Access Compliance Report

Public Rights-of-Way

Intersection ID: 10040755	Main Street: W_TREMONT_AV	Cross Street: N/A	Location: NW
ADA ID: 27DF65314F15	Ramp Type: PerpDiag	Initial Pass/Fail: Pass	Overall Compliance: No
		Severity Score: 0

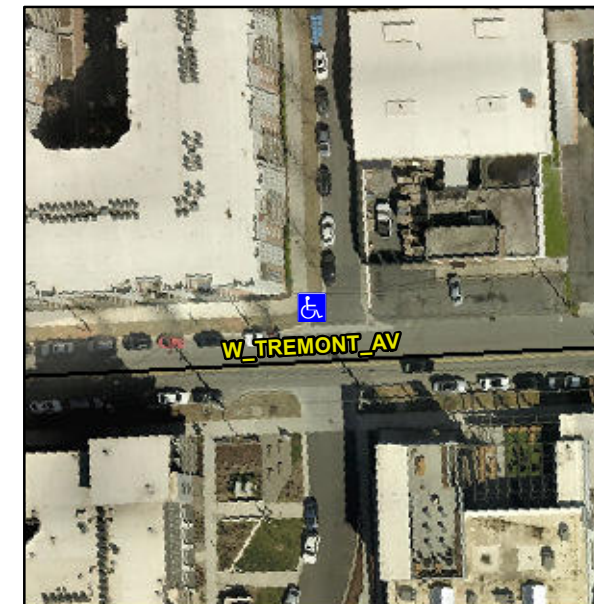
R304.5.3

Remove & Replace Landing.
